EPA REGION 8'S RESPONSE TO PETITION FOR REVIEW

Doc 001, EPA Dewey-Burdock Response to Public Comments,
including descriptions of changes from the 2017 draft to final UIC Class
III and Class V Permits, (November 24, 2020)

Response to Public Comments

Class III Area Permit No. SD31231-00000, Aquifer Exemption Decision

Figure S. Anticipated Project-Wide Flow Rates during Uranium Recovery and Groundwater Restoration

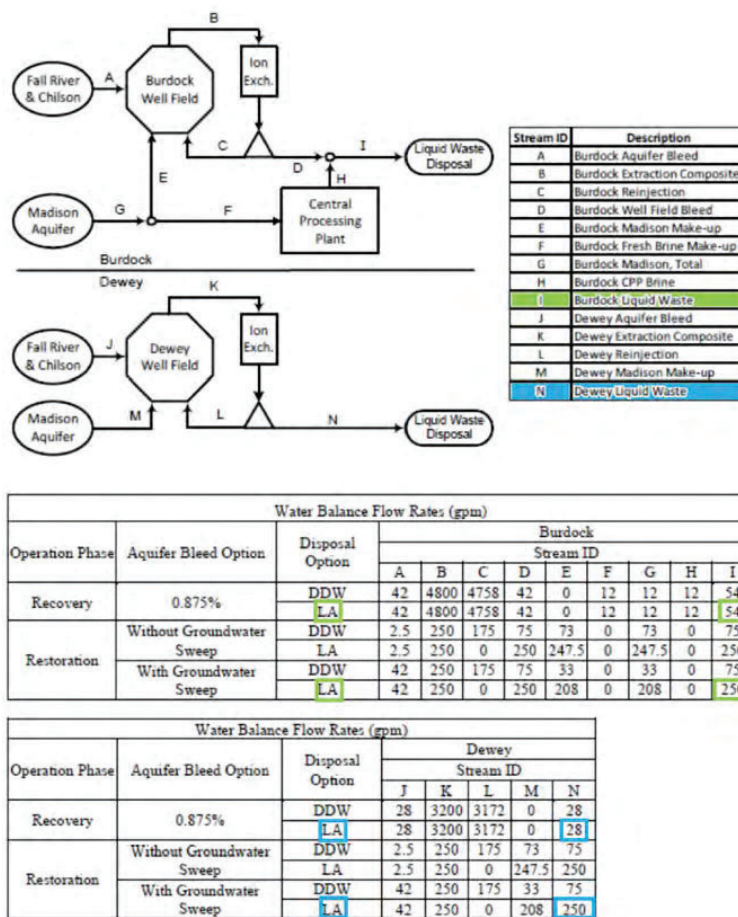
that Figure 7.1 of the Class III permit application and Table 5.3-2 of the Large Scale Mine Permit Application show that the maximum anticipated liquid waste flow rate during concurrent operations and aquifer restoration under the land application option is 582 gpm. Powertech requests correcting this statement as follows:

EPA agrees with Powertech's proposed changes in this comment and has made edits in the CEA as Powertech proposes in this comment. The 582 gpm flow rate is derived by adding up the waste stream flows from Figure 7.1 of the Class III permit application. The 582 gpm flow rate is the total of Burdock Liquid Waste (Stream ID I) during the uranium recovery phase for the land application disposal option (54 gpm), plus Burdock Liquid Waste (Stream ID I) for the Restoration phase, with Groundwater Sweep, land application disposal option (250 gpm) outlined in green in the Figure S below, plus Dewey Liquid Waste (Stream ID N) during the uranium recovery phase for the land application disposal option (28 gpm), plus Dewey Liquid Waste (Stream ID N) for the Restoration phase, with Groundwater Sweep, land application disposal option (250 gpm) outlined in blue in the Figure S below. Those numbers add up to 582 gpm.

Figure T. Pass Creek alluvium cross-section and the Burdock Area Pond locations for the Class V disposal option.

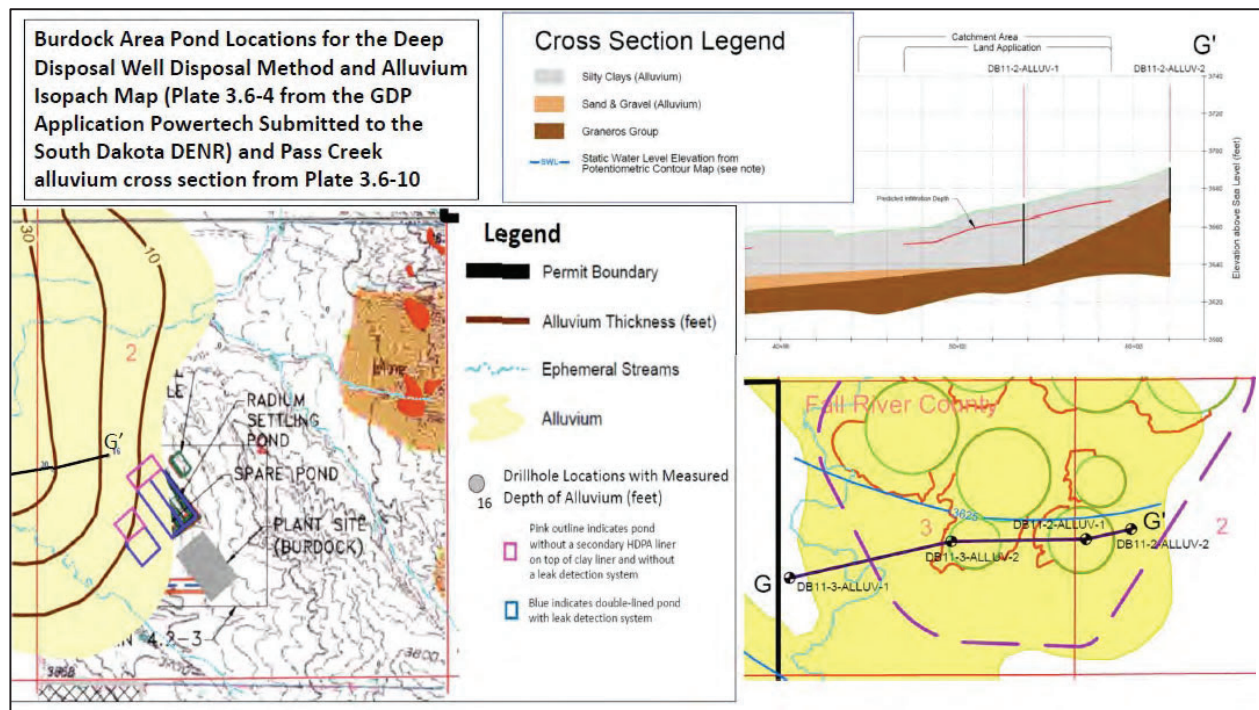
EPA does not agree with Powertech about the potential impacts from a pond leak in this area. EPA performed an analysis of the geological conditions underlying the Burdock Area Ponds to evaluate impacts from the potential leaking of ponds. EPA has concerns that although the ISR waste fluids would have been treated to remove radium, the stored water would still contain byproduct material and high TDS reject water from the reverse osmosis treatment system. Leaking from ponds in this area have the potential to affect alluvial aquifers. Plate 3.6-10 in the Groundwater Discharge Permit Application shows cross-sections of the Pass Creek alluvium and Appendix 3.6-A contains logs from Pass Creek alluvial

Because of EPA's concern about potential effects to these alluvial aquifers, EPA included a condition in Part II, Section I.4.a of the Class III Area Permit requiring the Permittee to submit information to the EPA Region 8 Air and Radiation Division to determine the applicability of the 40 CFR part 61, subpart W regulations, and if necessary, receive construction approval from EPA. If CAA subpart W applies to these ponds, Powertech will need to meet subpart W requirements. The surface impoundment design, construction, and operating requirements are found under 40 CFR § 264.221(c) which requires two or more liners, installation of a leak detection system, and a leachate collection and removal system between such liners.

Figure V. Burdock Area Land Application Area and proposed Perimeter of Operational Pollution (Sources: Groundwater Discharge Permit application Figure 6.1-3 and Class III Permit Application Plate 6.12)

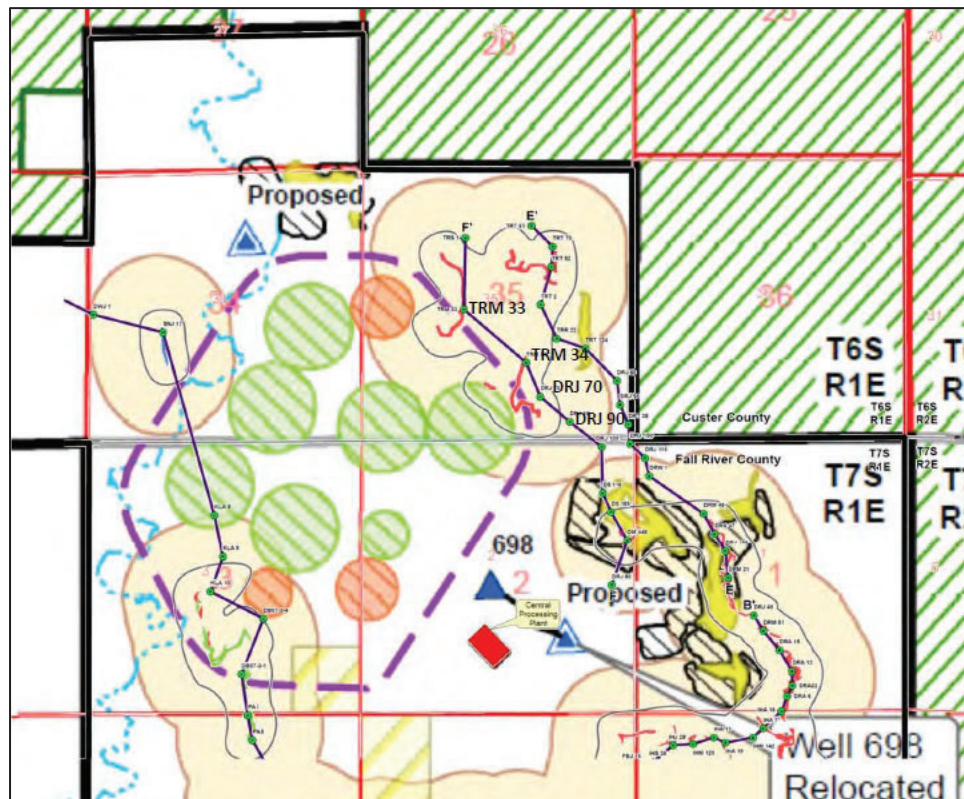
EPA reviewed drillhole data along northeastern POP boundary in the Burdock Area. Figure V shows the Burdock POP boundary from Groundwater Discharge Permit application. Figure 6.1-3 contains an excerpt from Plate 6.12 of the Class III Permit Application showing available cross-sections in the Dewey-Burdock Area. According to Class III Permit Application Plate 6.18 Cross-Section F-F', logs of drillholes TRM 33 and TRM 34 show 10 feet of Graneros Shale. Because the Graneros Shale has been eroded away in this area, logs of drillholes DRJ 70 and DRJ 90 show the Graneros Shale is absent above the Fall River Formation. Because these drillhole locations are located outside the POP boundary, they do not necessarily indicate the Graneros is less than 25 feet thick within the land application areas. Groundwater Discharge Permit application Plates 3.6-9 Cross-Section E-E' and Plate 3.6-8 Section D-D' show that the Graneros shale is 25 feet or more within the land application areas. Cross-Section F-F' in Plate 6.12 of the Class III Permit Application also shows that the Upper Fall River is not saturated at the locations of drillholes TRM 34, DRJ 70 and DRJ 90. Powertech proposes vadose zone monitoring at catchment areas (which are shown in Figures 6.1-2). EPA considered whether monitoring wells should

be completed in the Fall River aquifer at the northeastern POP boundary and determined that the catchment area vadose zone monitoring at the northeastern edges of the Burdock land application area will also serve as monitoring for the Fall River aquifer in this area. In addition, the Upper Fall River aquifer monitoring wells associated with Burdock Wellfield 8 will also provide monitoring for TDS, specific conductance, and alkalinity at the northeastern POP boundary.

Figure W Projected Construction, Operation and Decommissioning Schedule (Source: Figure 10.2 in the Class III Permit Application.

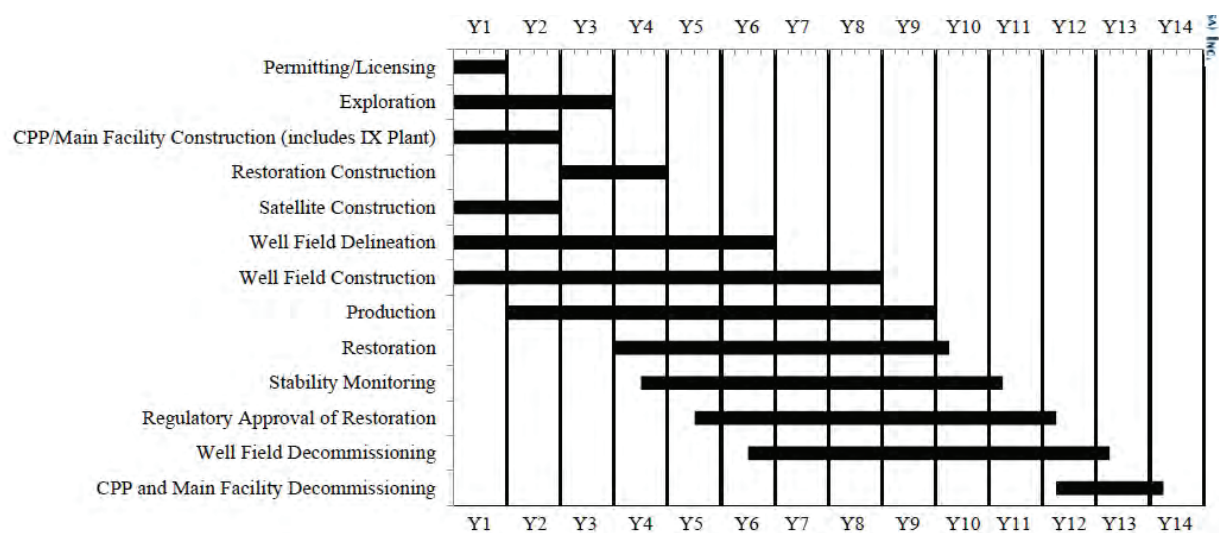
The Class III Permit Application includes the project timeline in Figure W showing an estimated life of the project to be 14 years. Not all 14 wellfields will be in operation at the same time, because Powertech plans to initiate wellfield phases (construction, operation, restoration, closure and decommissioning) sequentially for each wellfield. Figure X shows an example of this sequential approach for Burdock Wellfields 1 through 10.

Although the Class III Area Permit has been issued for the life of the project, if Powertech proposes additional wellfields, the company must apply for a major permit modification, which will trigger an updated CEA that will address additional wellfields and the extended project life. A major permit modification will also require another public comment period. Conducting an analysis before that time would be based on speculation instead of actual data. The Class V Area Permit expires after 10 years. Renewal of the Class V Area Permit will provide another opportunity for public comment and an updated CEA. By the time a Class V permit renewal or Class III permit modification occurs, operational information should be available on the amount of time actually needed for each wellfield phases to better inform the life of the project.

Figure 3.2-6: Overall Process Flow Diagram

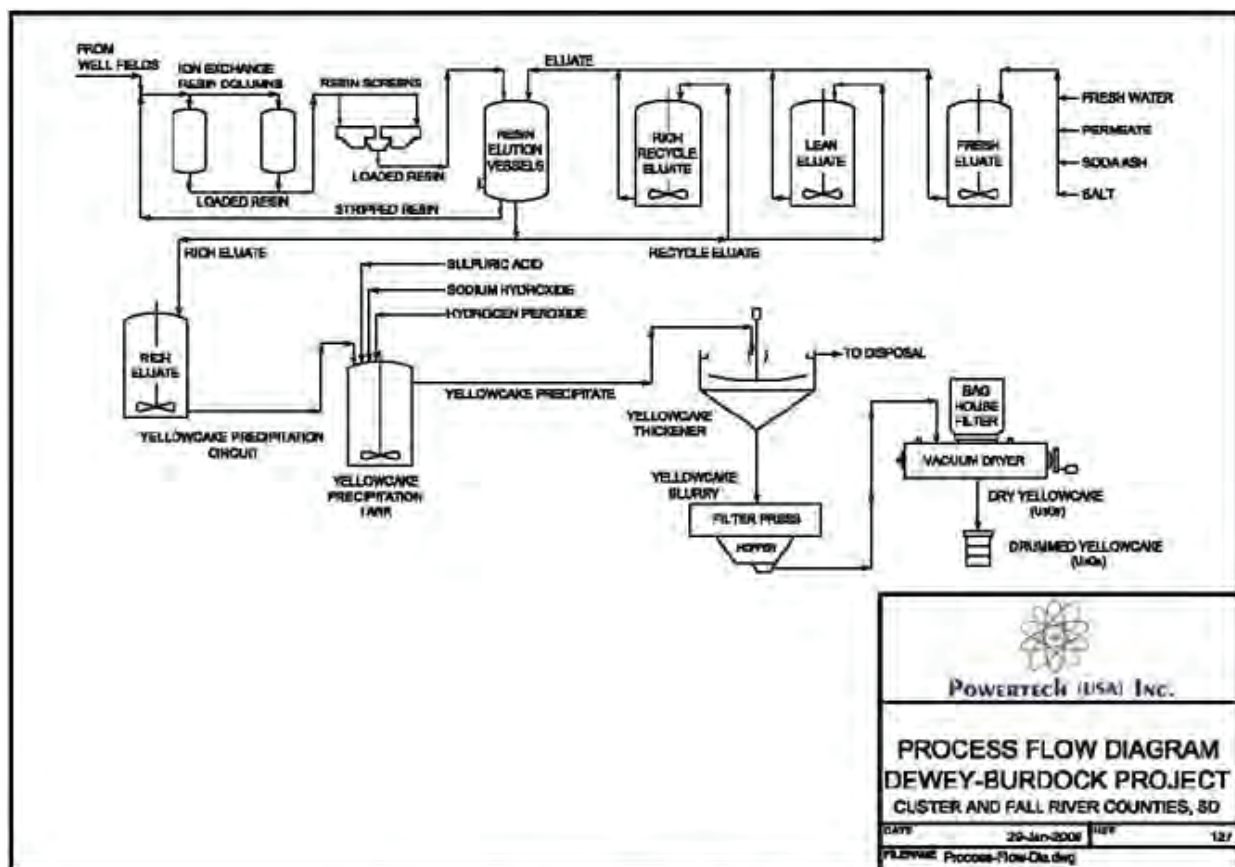
361. Powertech raises a comment regarding the statement in the CEA that Powertech proposes to store, use, and receive shipments of anhydrous ammonia (NH₃). According to Powertech, it does not propose to use ammonia at the Dewey-Burdock Project. Powertech refers to Figure 3.2-6 in the approved NRC license application and explains that it shows that sodium hydroxide will be used in the precipitation circuit instead. Powertech also refers to Table 3.2-1 in the approved NRC license application, which lists the process-related chemicals and quantities planned for the project, likewise does not include ammonia. Powertech requests removing mention of anhydrous ammonia from this paragraph.

EPA agrees with Powertech's comment and has updated the two references to "anhydrous ammonia" (NH₃) in the CEA Section 12.2, and instead replaced them with sodium hydroxide. We have included Figure 3.2-6 in the approved license application here.

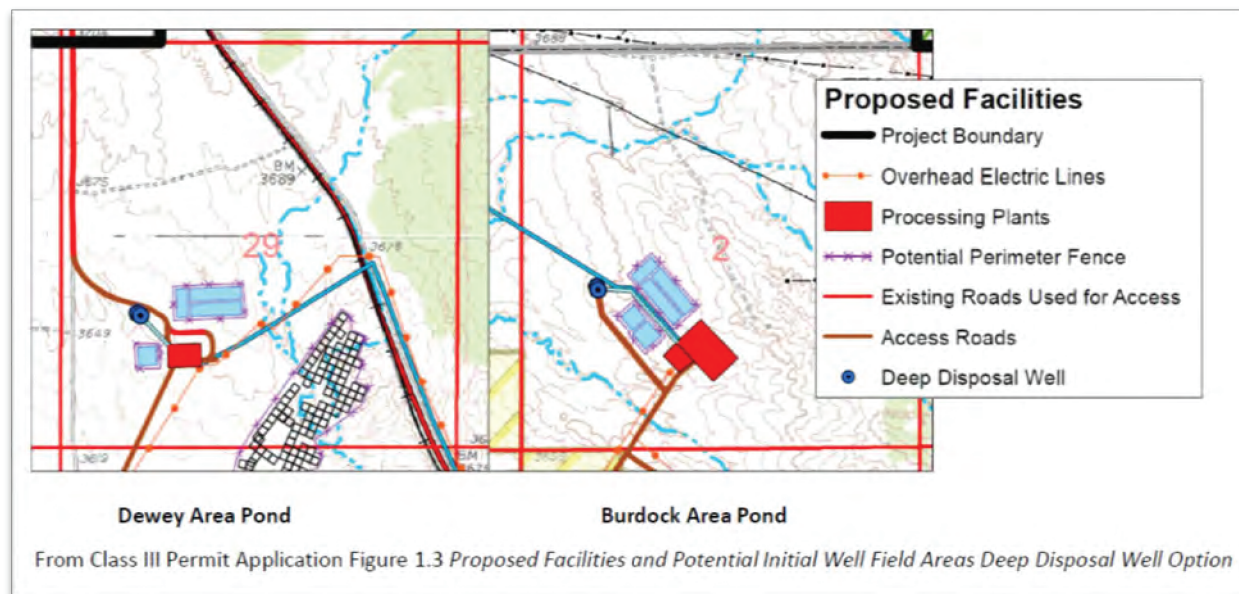
The Black Hills Army Depot is approximately 14 south of the Dewey Burdock project and will not be affected by the injection activity.
